# Technical Bulletin

<b>DP02</b>	<b>TB0042-2011</b>	<b>Élan Motorsports Technologies</b>	
<b>From:</b>	<b>John Harris</b>		
<b>Subject:</b>	<b>2.0L MZR Engine Install</b>	<b>Date:</b>	<b>Nov 22<sup>nd</sup>, 2011</b>

## Attention all Élan DP02 teams

*Figure 1: Bellhousing Shims*

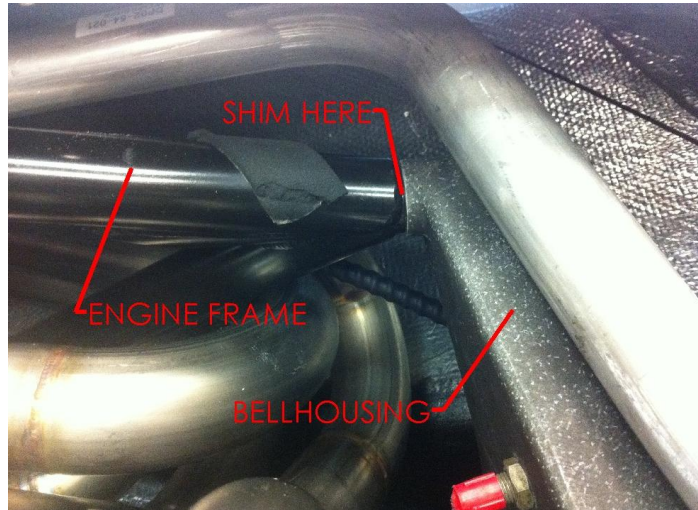
It is worth noting that, due to manufacturing tolerances, all DP02 chassis were originally assembled with the appropriate amount of shims between the bellhousing and engine frame bosses (see Figure 1). This is to ensure the bellhousing does not crack due to stresses induced during installation. The conversion of any DP02 chassis to accept a new motor will inevitably require this shimming process to be repeated.

9. Tighten the three bolts securing the front upper engine mount to the engine.
10. Using a pair of calipers, carefully measure the gap between the bellhousing and the engine frame bosses at all four mounting locations. Acquire the corresponding thickness and amount of shims required to take up the gap at these four locations.

11. Remove bellhousing and engine. Install shims in their appropriate locations.
12. Reinstall bellhousing, engine and included mounts leaving **all** fasteners loose.
